Our Ref: 16111

3 April 2019

**RE: WESTFIELD WARRINGAH MALL REDEVELOPMENT AMENDED STAGE 2 DA
ADDITIONAL TRAFFIC MODELLING**

Figure 1: Standard Ingress/Egress on Condamine St (Option A)

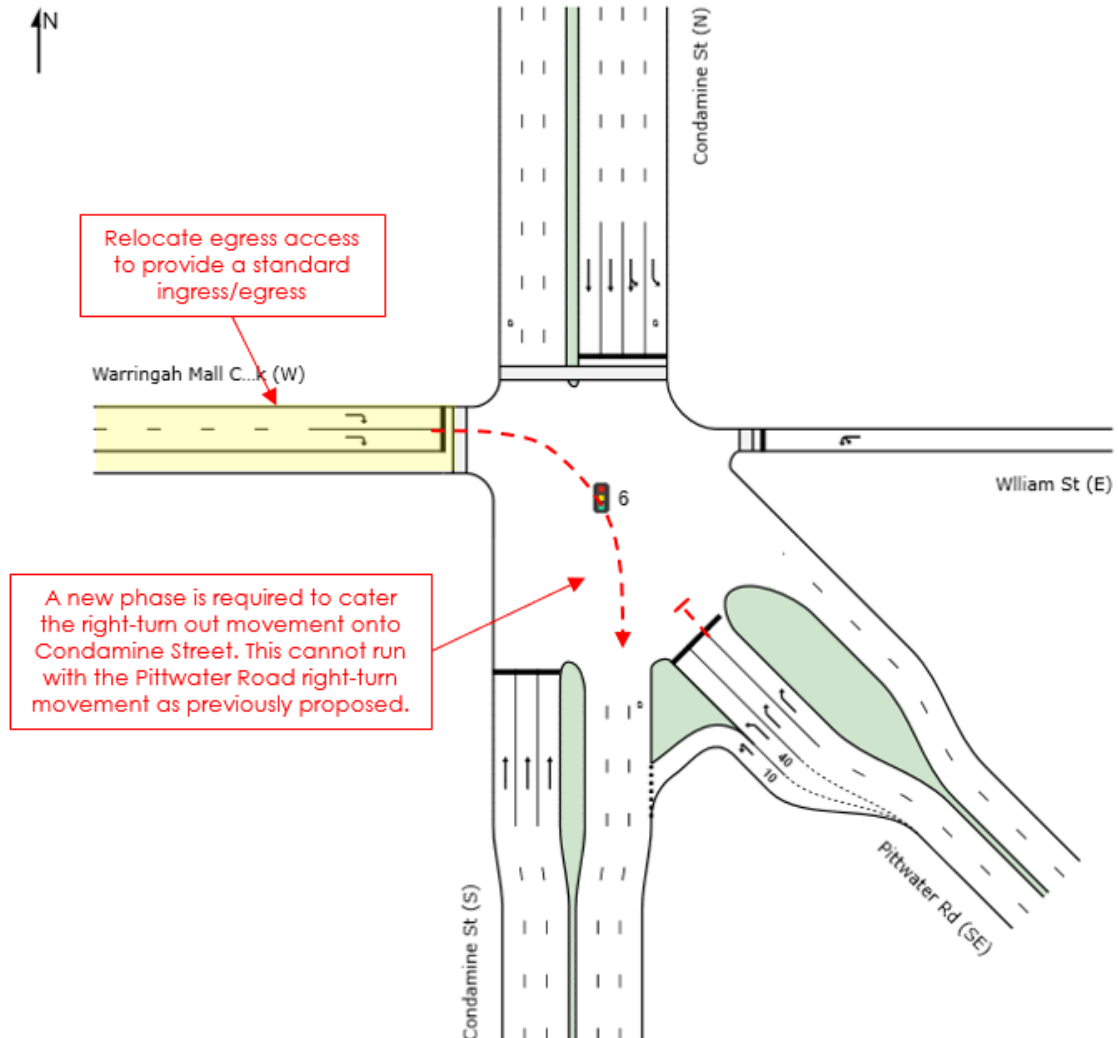
This option (Option A) reflects Roads and Maritime's comments to provide a standard ingress and egress arrangement. Under this option, an additional signal phase would be required to cater for the right-turn egress movement onto Condamine Street. This means less green time for existing movements at this Condamine Street-William Street intersection, which may not be supported by Roads and Maritime.

- Option A involves providing a standard ingress/egress access on Condamine Street as requested by Roads and Maritime would result in unsatisfactory intersection performance (LoS F) at the Pittwater Road-William Street intersection as a new signal phase is required to accommodate right turn movements out onto Condamine Street. Extensive delays and queuing will also be experienced for vehicles exiting the Centre onto Condamine Street. To address this issue, additional green time would be required to accommodate Centre related traffic. This means less green time on Pittwater Road and Condamine Street, which is unlikely to be supported by Roads and Maritime as it would affect the signal coordination on Pittwater Road. This is applicable to both Scenarios 5 and 6.

Figure 2: No Egress on Condamine St (Existing Access Arrangements, Option B)

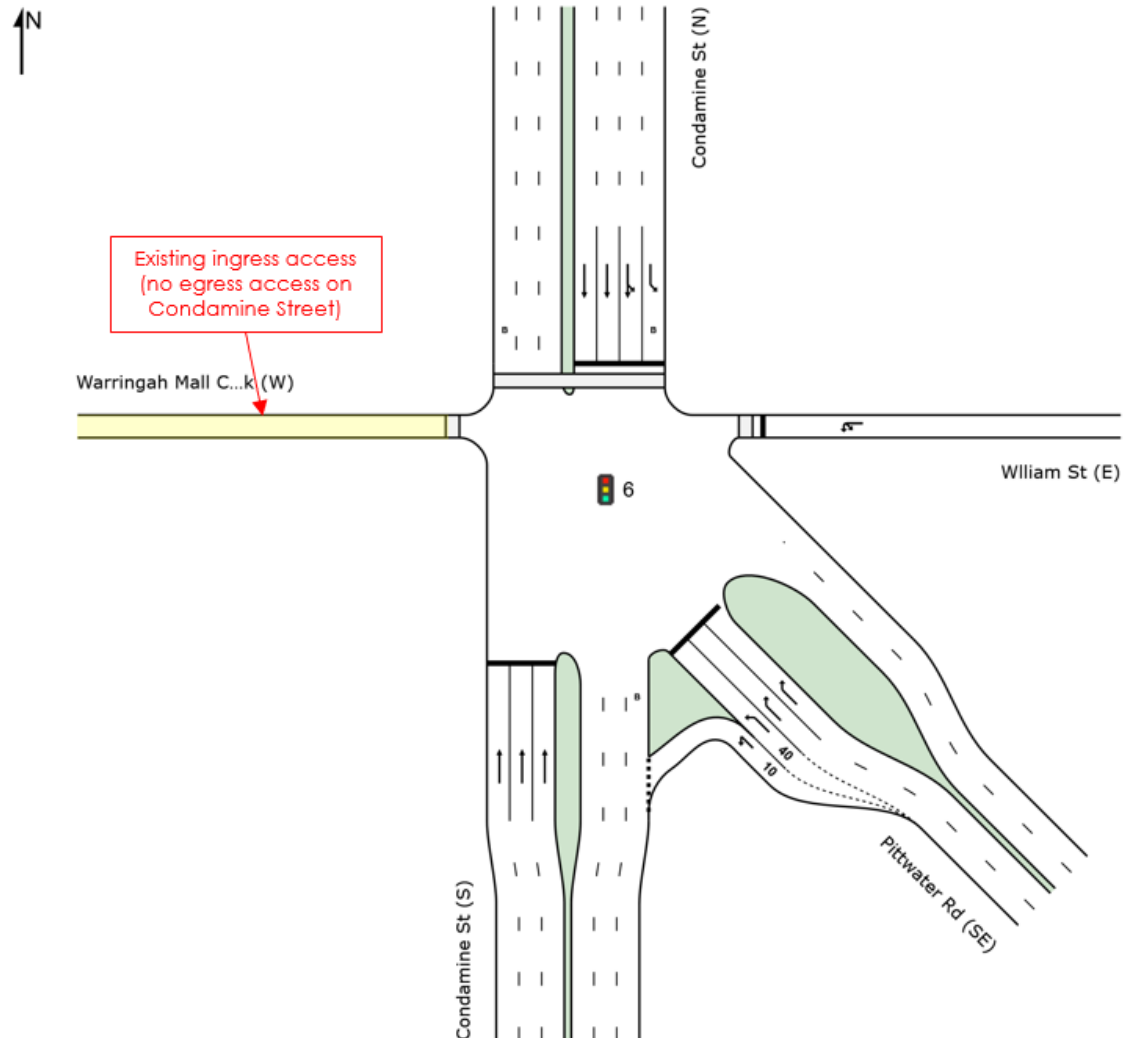
Under this option (Option B), the Stage 2 development traffic would be accommodated using existing access arrangements i.e. no proposed egress off Condamine Street. This means that all traffic from Centre wanting to travel southbound along Condamine Street would be accommodated on Cross Street (instead of using the proposed Condamine Street egress as proposed in Option A above).

- Option B examines an access arrangement in which there is no egress to Condamine Street and traffic wanting to travel southbound would do so via the existing vehicle access arrangements on Cross Street. This would result in traffic capacity issues on Cross Street between Green Street and Pittwater Road. This unsatisfactory network performance is unlikely to be supported by Roads and Maritime. Additional lane capacity on Cross Street would need to be considered between Dale Street and Pittwater Road, particularly the right-turn lane capacity onto Pittwater Road. These changes will require land to be provided to Roads and Maritime on Cross Street and Pittwater Road site frontages. However, both the Green Street and Dale Street would continue to experience traffic capacity stress with or without the Cross Street additional capacity discussed above. These issues exist in Scenario 5 and 6.

Figure 3: Egress Access only on Condamine St (Option C)

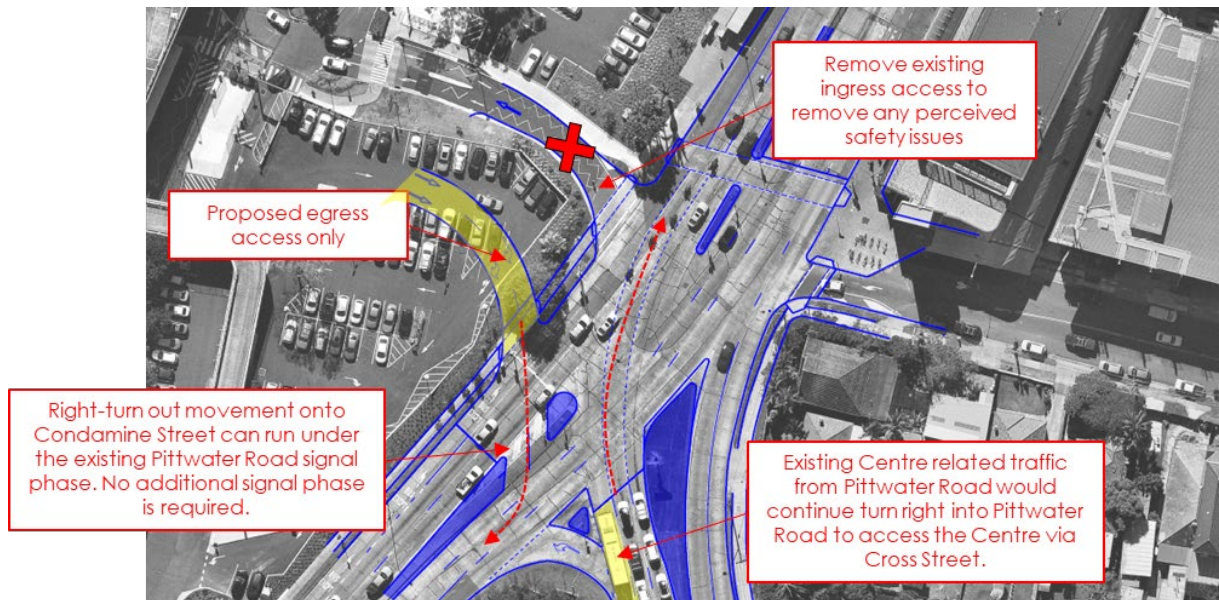
This option (Option C) removes the existing ingress access on Condamine Street, opposite William Street, to accommodate a proposed egress access only to cater for right-turn movement onto Condamine Street similar to the original proposed Condamine Street egress detailed in the DA traffic assessment. This option is consistent with Roads and Maritime request to provide a standard egress on Condamine Street.

This right turn egress will be configured in such a way to enable the right turn movement from the Centre to operate in the same signal phase as the Pittwater Road northbound traffic movement such that no additional signal phase is required. This is similar to that previously proposed at this location (as reported in the original DA traffic assessment report), but involves the removal of the existing ingress access.

- Option C involves providing an egress access only on Condamine Street which is consistent with the previous proposal. However, this option also involves the removal of the existing ingress access on Condamine Street, opposite William Street, to provide a standard egress as requested by Roads and Maritime. This means traffic accessing the Centre from Pittwater Road (south) that used to rely on the ingress opposite William Street would do so in the future via Cross Street. This would result in an increased left-turn demand on Pittwater Road (south) onto Cross Street (west) which already operates poorly due to traffic capacity issues on Cross Street. This option would require a new (uncontrolled) left turn slip lane provided on Pittwater Road (south) at Cross Street to maintain an acceptable intersection performance at the Pittwater Road-Cross Street intersection. The above identified issues relate to both Scenarios 5 and 6.

Any safety issues identified by the road safety audit that can not be satisfactorily resolved, an alternative option would be to revert to Option C as assessed in this letter. This option, as it removes the existing ingress, does not have any safety concerns raised by Roads and Maritime and would also provide satisfactory intersection performance.

Figure 4: Proposed Dale St Two-Way Arrangements (Scenario 5)

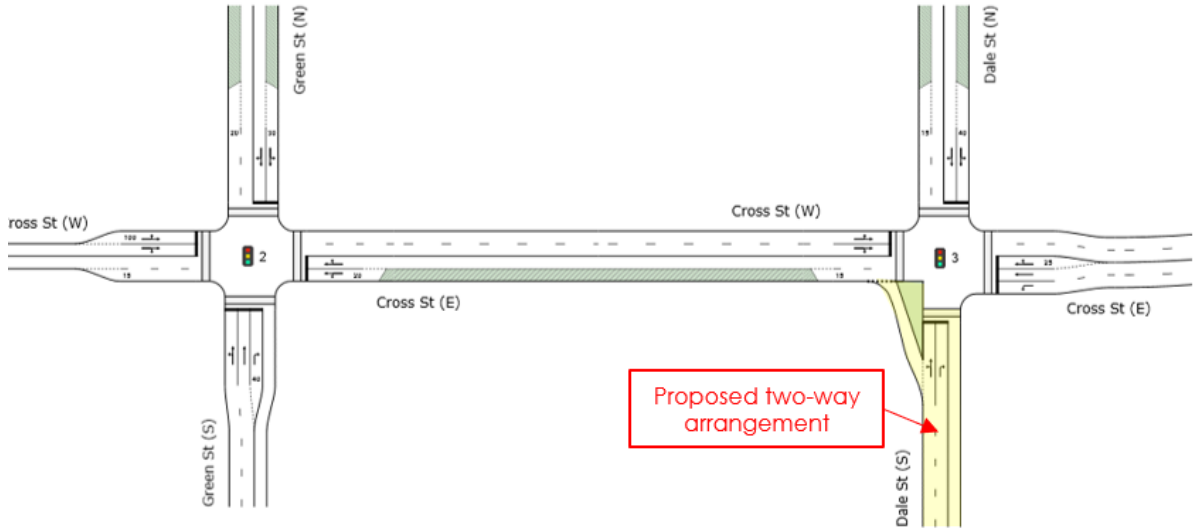
The previous assessment included the proposal to convert Dale Street into a two-way road to assist with alleviating traffic demand on existing site access points, particularly at the Green Street site access point. Under a one-way access option on Dale Street which is consistent with existing access arrangement, traffic would leave the site from Green Street onto Cross Street.

- The option to convert Dale Street to two-way will assist alleviate traffic demand at the Green Street access onto Cross Street in Options A and C. In Options A and C, this is not expected to result in any adverse traffic issues on the network as the model indicates that eastbound queues on Cross Street on approach to Pittwater Road do not (on average) queue beyond the Dale Street access.

Figure 5: Dale St One-Way Arrangements (Existing Conditions, Scenario 6)

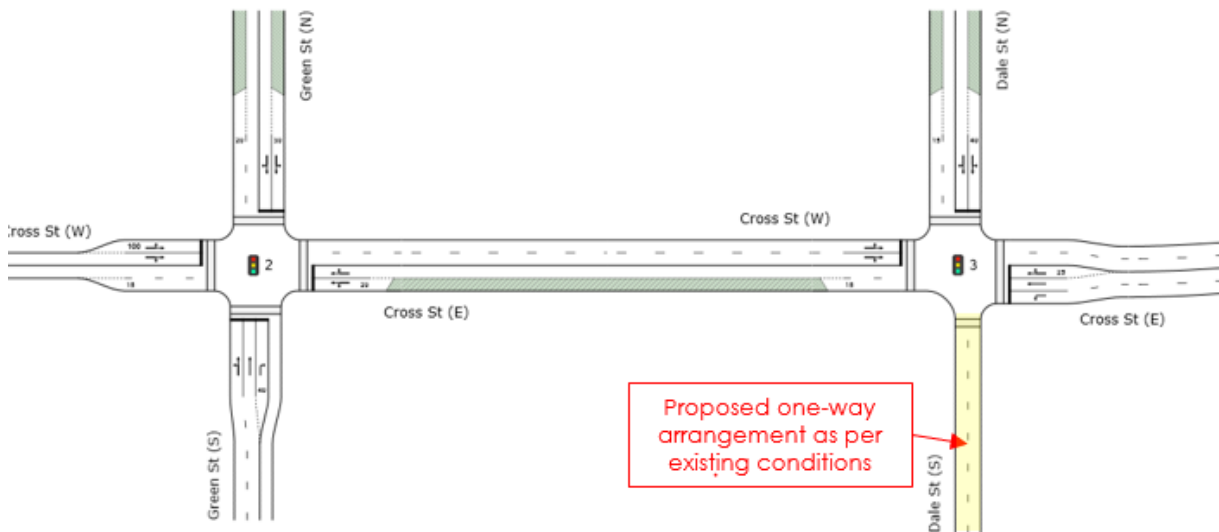
- The option to retain Dale Street as one-way will address Roads and Maritime's concerns regarding right turn issues from Dale Street onto Cross Street. The modelling shows that the additional traffic generated by the Stage 2 development on the Cross Street access would continue to operate at a satisfactory level of service (LoS B) if an egress access is provided on Condamine Street. Otherwise, this access would operate poorly due to traffic capacity issues on Cross Street as outlined above.
